Access Compliance Report Public Rights-of-Way (Curb Ramps)

Main Street: MAGNOLIA_DR		Cross Street: BLUE_SPRUCE_DR		Location:	E
ADA ID: RPAT211101143831	Ramp Type: Type 4 - Parallel	Initial Pass/Fail: Fail	Overall Compliance: No	Severity Score:	32
Codes/Mitigation Info/Possible Solution			Field Measurements/Component Compliance

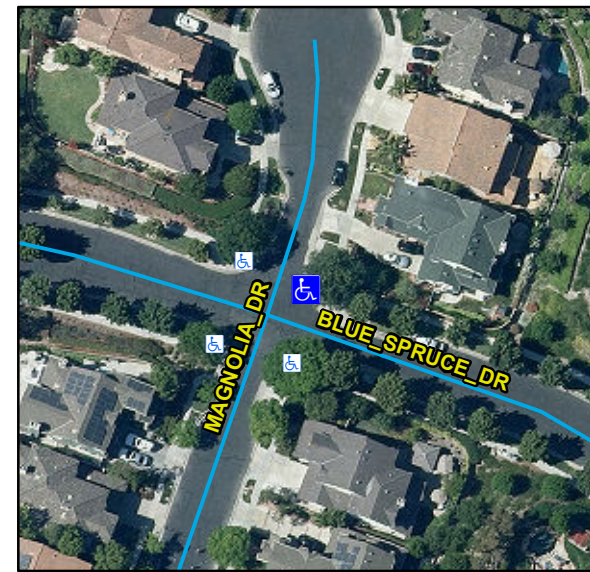
Compliance	Description	Data	Compliance	Description	Data
N/A	Ramp Length LT (in)	115	N/A	Ramp Length RT (in)	110
Yes	Ramp Width LT (in)	54	Yes	Ramp Width RT (in)	54
Yes	Ramp Run Slope LT (%)	2.7	No	Ramp Run Slope RT (%)	12.5
No	Ramp Cross Slope LT (%)	3.9	No	Ramp Cross Slope RT (%)	4
N/A	Landing Present	N/A	N/A	DWS Provided	N/A
N/A	Landing Length (in)	N/A	N/A	DWS Contrast	N/A
N/A	Landing Width (in)	N/A	N/A	DWS Length (in)	N/A
N/A	Landing Run Slope (%)	N/A	N/A	DWS Full Width	N/A
N/A	Landing Cross Slope (%)	N/A		DWS Offset Type	N/A
N/A	Landing Movement Obstructed?	N/A	N/A	DWS Offset Left (in)	N/A
	Landing Movement Type	N/A	N/A	DWS Offset Right (in)	N/A
N/A	Landing Shared	N/A			
N/A	Clear Space	Yes			
N/A	Clear Space To Crosswalk (in)	N/A			
N/A	Marked Crosswalk 1	No	N/A	Marked Crosswalk 2	No
	Crossing 1 Direction	NW		Crossing 2 Direction	SW
	Marked Crosswalk 1 Width (in)	N/A		Marked Crosswalk 2 Width (in)	N/A

N/A	Ramp Inside Crosswalk 1	N/A	N/A	Ramp Inside Crosswalk 2	N/A
	Crossing 1 Slope (%)	4.9		Crossing 2 Slope (%)	0.8
	Crossing 1 Cross Slope (%)	1.5		Crossing 2 Cross Slope (%)	6
N/A	Gutter Ponding	N/A	N/A	Curb Slope	13.4
Yes	Gutter Lip Height (in)	0		Road Run Slope (%)	4.8
N/A	Gutter Run Slope (%)	N/A		Road Cross Slope (%)	3.5
N/A	Gutter Cross Slope (%)	N/A	No	Perpendicular Joint Present	No
Yes	Overall Surface Condition	Acceptable			
	Cross Gutter Present?	No		Spandrel Present?	No
	Replace Cross Gutter?	N/A		Replace Spandrel?	N/A

Remove & Replace Curb Ramp With Two New Directional Ramps or Equivalent.
